**Addendum No. 1**  
**Date: June 16, 2022**

**Renovations to the Clay County  
Career Academy for the  
Clay County Board of Education  
Ashland, Alabama**

**MCKEE PROJECT NO. 21.239**  
**ALABAMA DIVISION OF CONSTRUCTION MANAGEMENT NO. 2022268**

NEW CMU LINTEL IN EXISTING CMU WALL DETAIL

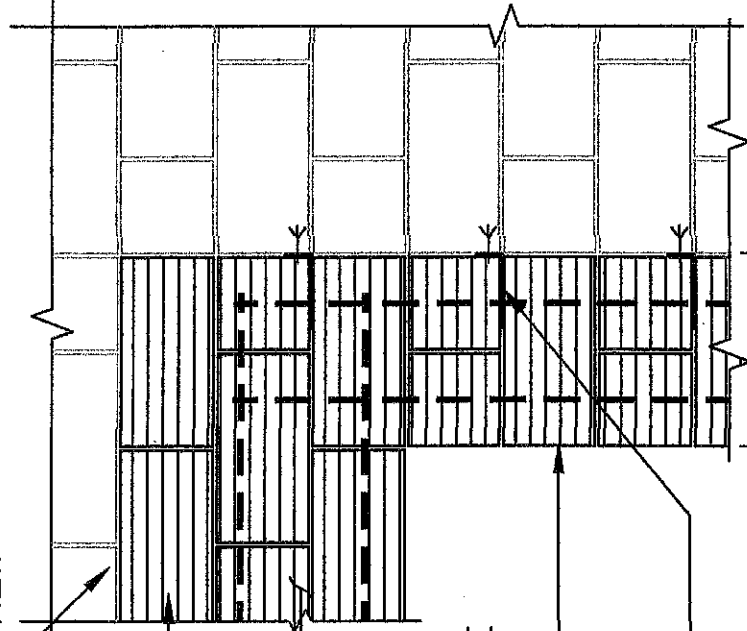
- A. Sheets **E0.1, E1.1, E1.2, E2.1, E3.1, E3.3, E5.2 and E7.1, all REVISED 6.8.22**, herein.
- B. Attached **Detail of "New CMU Lintel In Existing CMU Wall Detail"**, herein.

**Question 9:** Doors that are to be cut into and/or patched back into masonry openings, we need more structural detail for infilling the openings and a detail for installing new openings with lintel and reinforcement requirements.

**Answer 9:** See attached “New CMU Lintel In Existing CMU Wall Detail” included in this addendum.

**Answer 10:** Contractor is to carefully demo as detailed for new door opening, salvage structural glazed tile with cove base for re-use at new CMU jambs.
